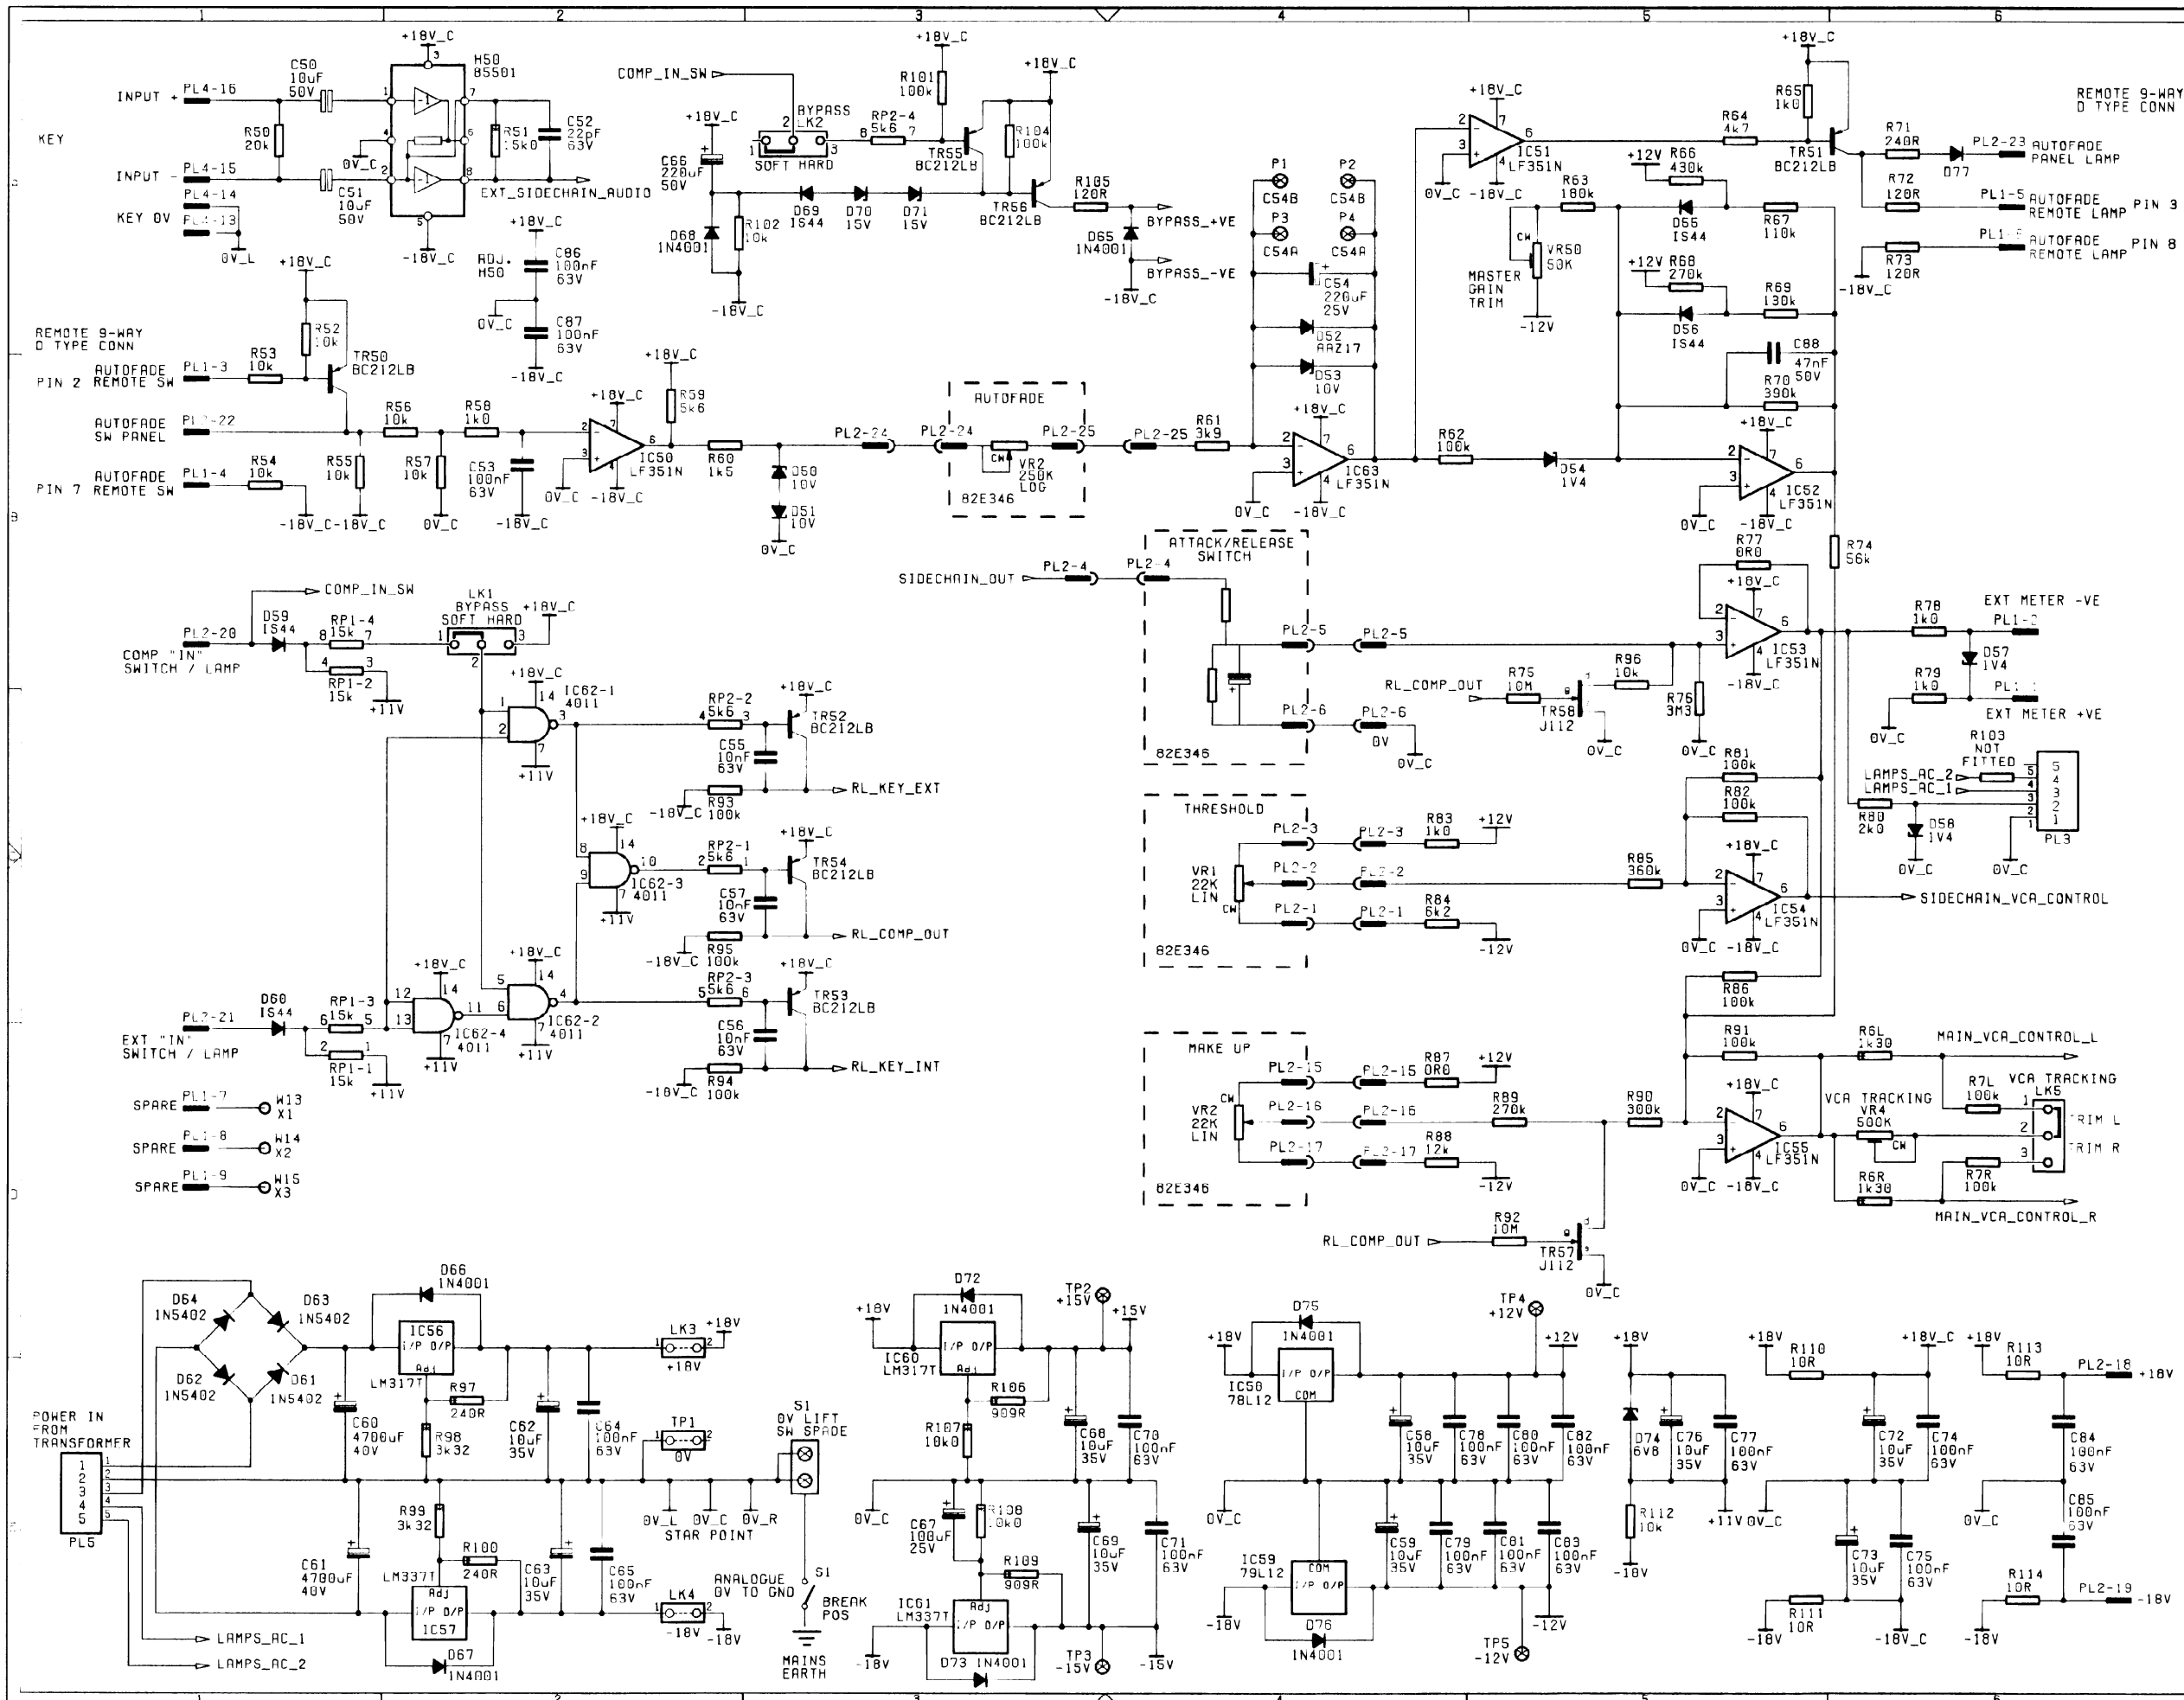
COPYRIGHT © SSL ALL RIGHTS RESERVED. THIS DOCUMENT MAY NOT BE REPRODUCED IN ANY FORM WITHOUT THE WRITTEN PERMISSION OF SOLID STATE LOGIC.			
REV	ISS	DATE	DETAILS
0	A	6 FEB 90	NEW DRAWING BC STEFF
0	B	14 FEB 90	C88 47N ADDED BC R74 WAS 68K NOW 56K STEFF
0	C	20 FEB 90	R103 NOW SHOWN BC NOT FITTED STEFF
1	A	5 APR 90	VR4 WAS 124NBXXXBC NOW 124NB2XX STEFF
